The Hills Shire Council Engineering Comments:

SSD 83112728 – Carrington, Fishburn and Sexton Ave

Figure 10 Local Street – Land Dedication Plan

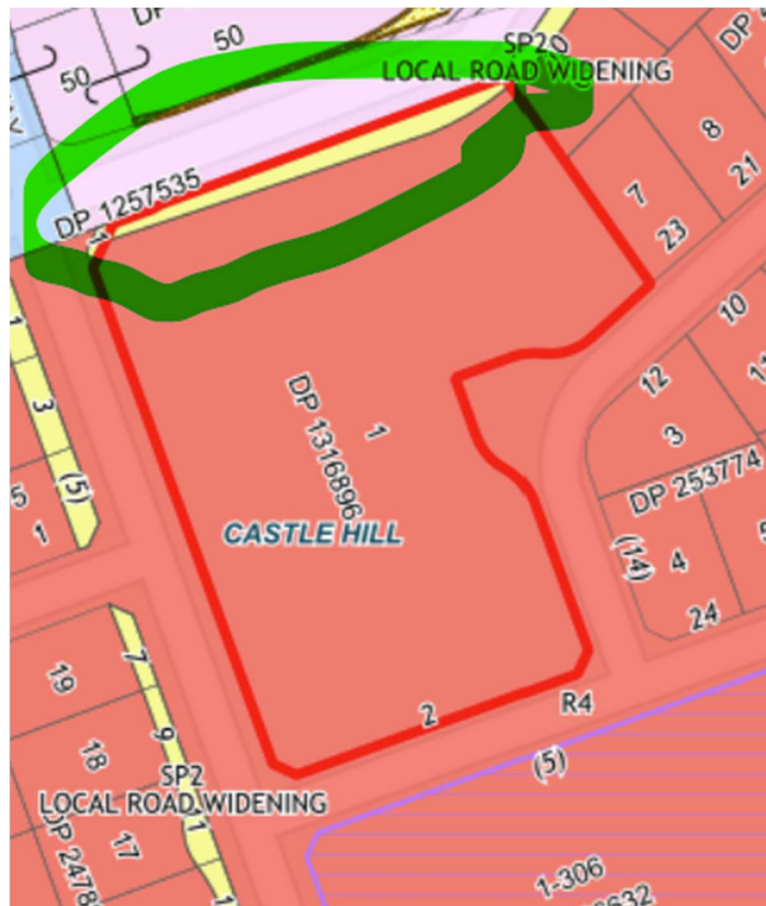
1. The development fronts to four road frontages Carrington Road, Middleton Avenue, Fishburn Crescent and Sexton Avenue, all three roads except Middleton Avenue are subject to road widening.
2. A Subdivision Concept Plan is required detailing the amendments below:
 - (a) The Carrington Road widening consistent to the SP2 zone of the LEP must be identified as a separate lot for acquisition by council as part of Carrington Road upgrade works.

- (b) The 2m road widening across Fishburn Crescent and Sexton Avenue frontages must be designed to integrate with existing carriageway widths, constructed and dedicated at no cost to council as part of this application. An annotation regarding the 2m road dedication at no cost to council must be included in the Subdivision Plan.

Carrington Road Upgrade

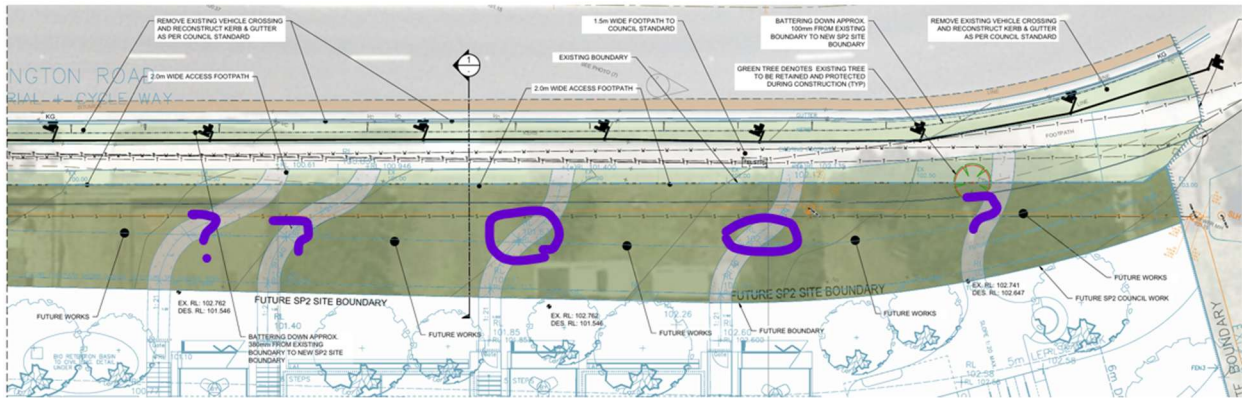
3. Council has commissioned a detailed design for Carrington Road upgrade works that needs to be used in preparing any activities proposed within the SP2 land identified for road widening as stated above. Council's Infrastructure Team (Katherine Munroe) shall be contacted for the progress and design update.
4. Until the ultimate upgrade works on Carrington Road is completed, the development must carry out Interim improvements to facilitate public activities including shared cycle and pedestrian path and footpath verge. Therefore, the SGC's design must be amended to detail the interim and ultimate activities separately.
5. Pedestrian footpath connections are shown on the plan (snip below); however, feasibility of such connections must be demonstrated for both Interim and Ultimate scenarios, providing longitudinal sections, existing and design levels to ensure the design compatibility.

6. Adequate cross-sections prepared at 5m intervals illustrating the full width of the road works extended to the site boundaries including any earth works must be detailed. The interim works shall be distinguished with separate colours against the ultimate design and construction referenced from council's design.

7. If the existing kerb is proposed to be replaced across the entire frontage the need for it must be further investigated and addressed.

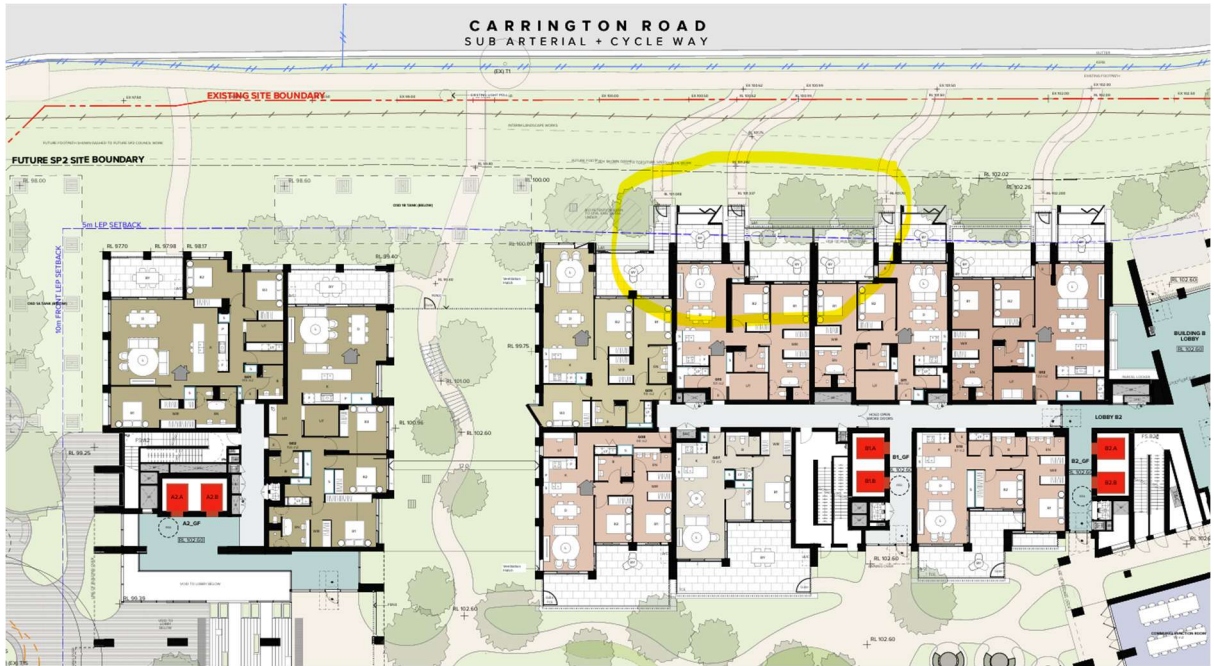
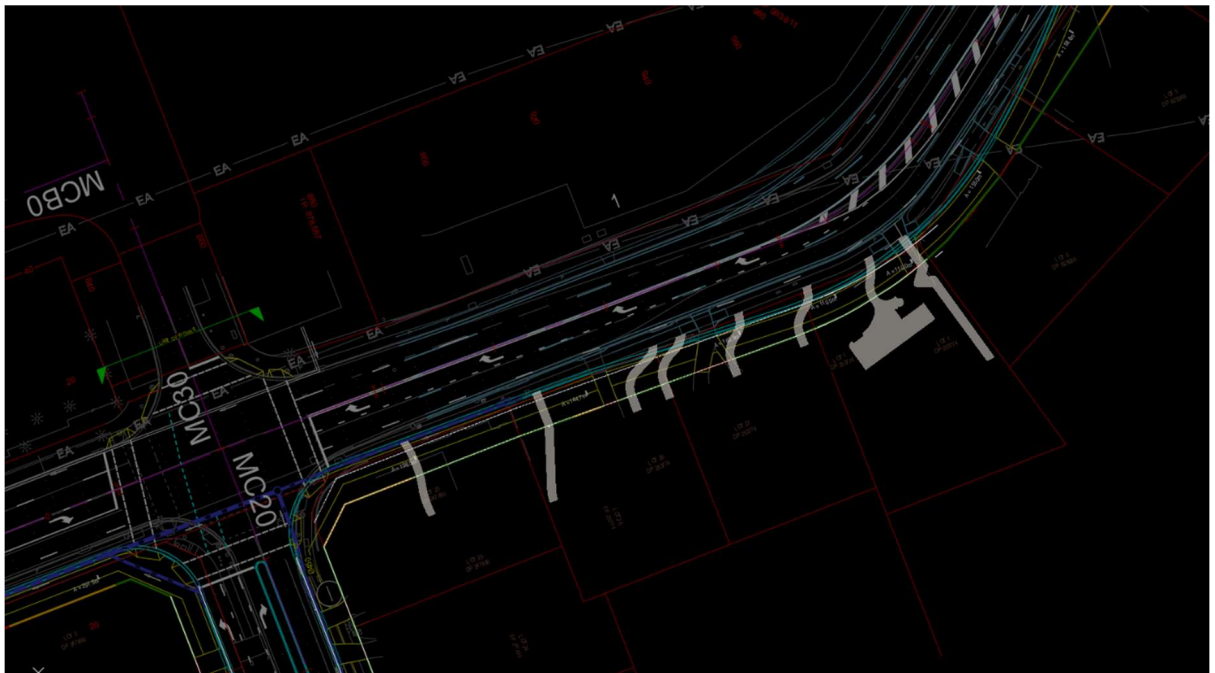
- *The proposed ground floor units and their connection to Carrington Road. The units circled in yellow will be a bit higher than the road levels. When the time comes to upgrade Carrington Road Council may need to construct some sort of ramp (especially for disabled access). They seems to like winding paths – not sure if this relates to getting path slopes to work or if they think it is more visually appealing.*
- *The levels shown on pits for the OSD tank adjacent to Carrington Road appear to be higher than the proposed footpath levels at the boundary. Is that an issue?*

To assist with the Carrington Road frontage I have placed the proposed paths on the design plans (both existing and proposed are shown). For internal purposes I have attached the proposed road layout, long section and cross sections. The plans show proposed drainage but it would be reviewed when the 'for construction' plans are prepared.

Following on from internal discussions, the Carrington Road design has the kerb and gutter on the eastern side of Middleton Avenue moving 200mm to 250mm closer to the boundary. Ultimately its location will be decided by the future traffic signal design. There will be a median of some form in Middleton Avenue.

Figure 8 Indicative Street Network and Hierarchy
 within the Deferred Area will be subject to further Master Planning)

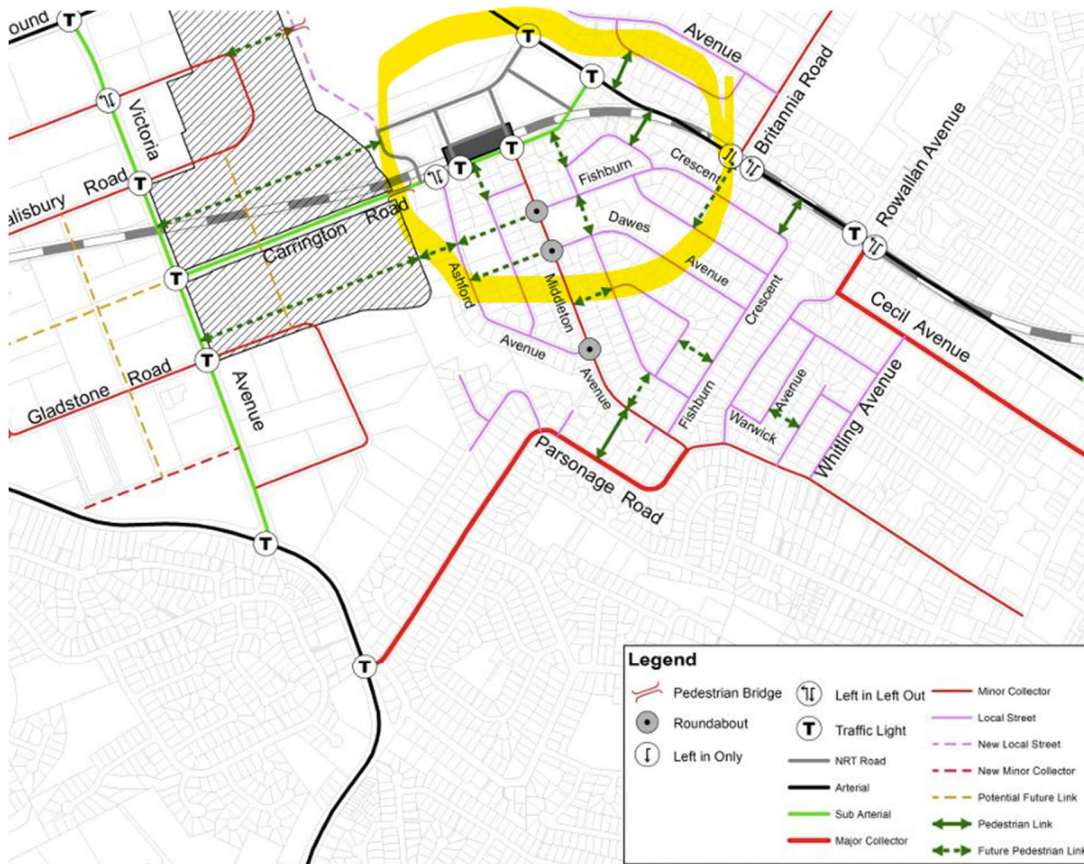
8. A roundabout at the intersection of Middleton Ave and Fishburn Crescent will be provided as per the Figure 8 of the DCP Part D Section 19 – Showground Station Precinct. The road design must include an overlay of council’s roundabout design to demonstrate that the existing road reserve at the intersection is adequate and no further road widening at the southern corner of the development is required to accommodate the roundabout and associated median.
9. Council’s Infrastructure Team (Tony Napoli) shall be contacted for design details relating to the roundabout. An overlay of the design must be presented on all relevant drawings.

Middleton Avenue Upgrade:

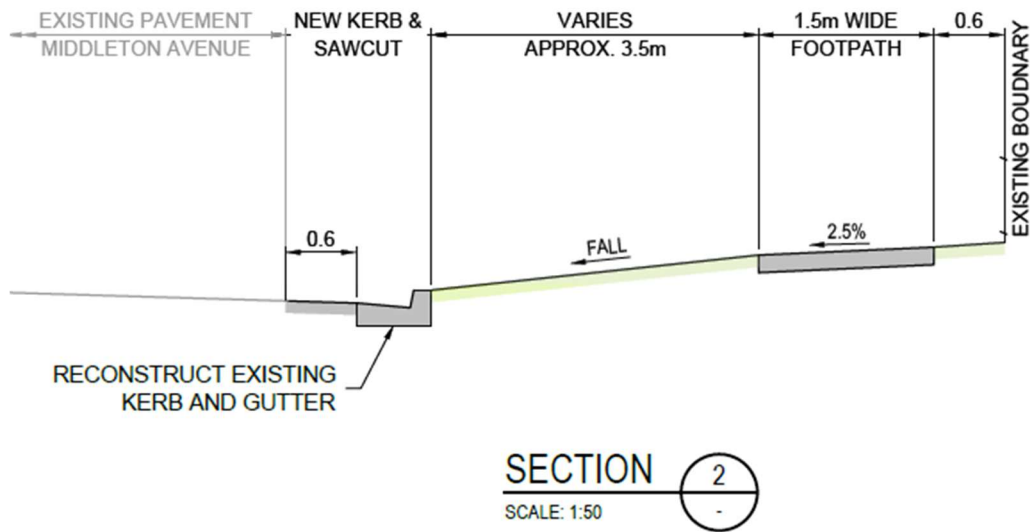
10. Works proposed within Middleton Avenue, fronting the development will be upgraded to minor Collector Road standards as per the Figure 8 of the DCP when land acquired for road widening on the opposite side.

Fishburn Crescent and Sexton Avenue Upgrade

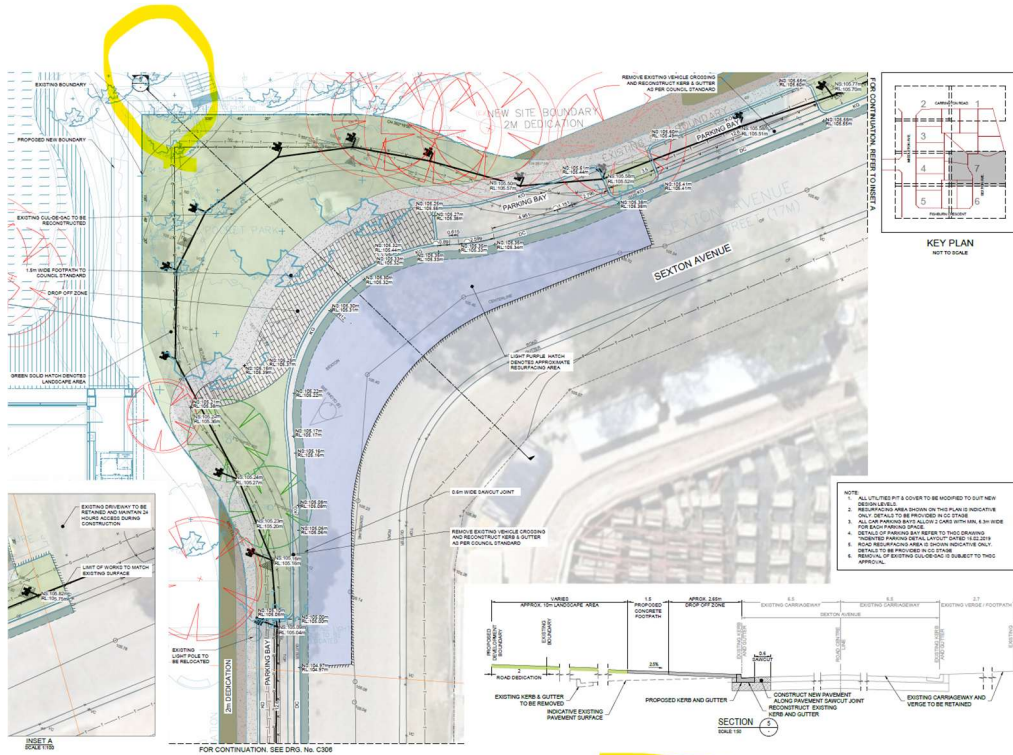
13. The proposed upgrade works on Fishburn Crescent and Sexton Avenue attempt to address the DCP Local Road design requirements including 2m wide road widening dedication. However, number of indented parking spaces provided within the road reserve is inadequate, hence does not improve public parking bays. The design must be amended to include additional parking bays.
14. The road design must incorporate adequate dimensions and design levels to ensure the design compliance.

Site Stormwater Management

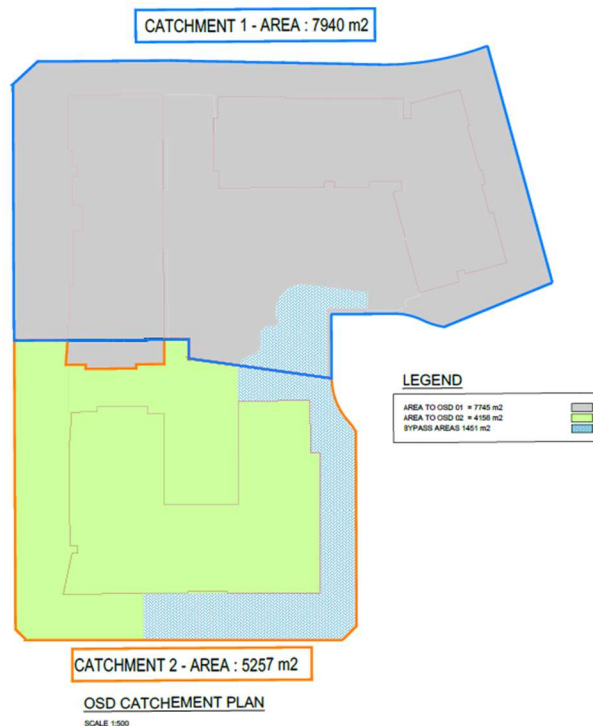
17. The Stormwater Concept Design drawings and associated report propose two OSD sub-catchments controlled by two OSD tanks. The OSD tank 1 has two separate chambers linked to achieve the required volume. However, the design integration of the two chambers named Volume 1 and Volume 2 have not been demonstrated with adequate design details including pipe sizes connecting the tanks, levels etc. Amended design documents must detail hydraulic integration of the two chambers.

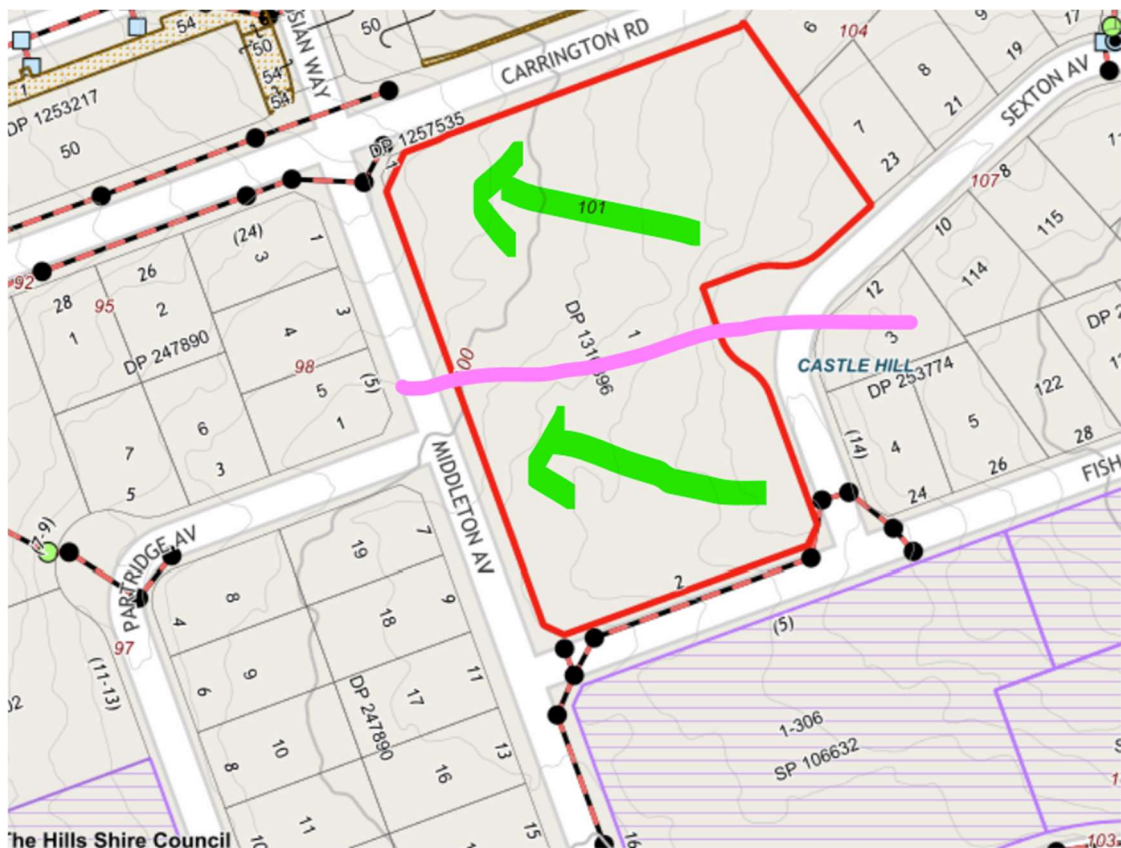
18. Noting that some areas of the development bypass the OSD tanks. Therefore, the OSD design calculations must be amended using the actual sub-catchment areas as site areas and insert the bypass area at appropriate place to ensure the design calculations are true representations.
19. The Sub-Catchment 2 is proposed to be controlled by the OSD tank 02. However, the outlet pipe has been directed to a drainage pipe proposed across Middleton Avenue and Carrington Road intersection. As this catchment 02 does not belong to Carrington Road drainage network and the downstream drainage is not designed to accommodate this runoff, a separate kerb inlet pit and pipe extension must be provided to extend to the Patridge Avenue network.
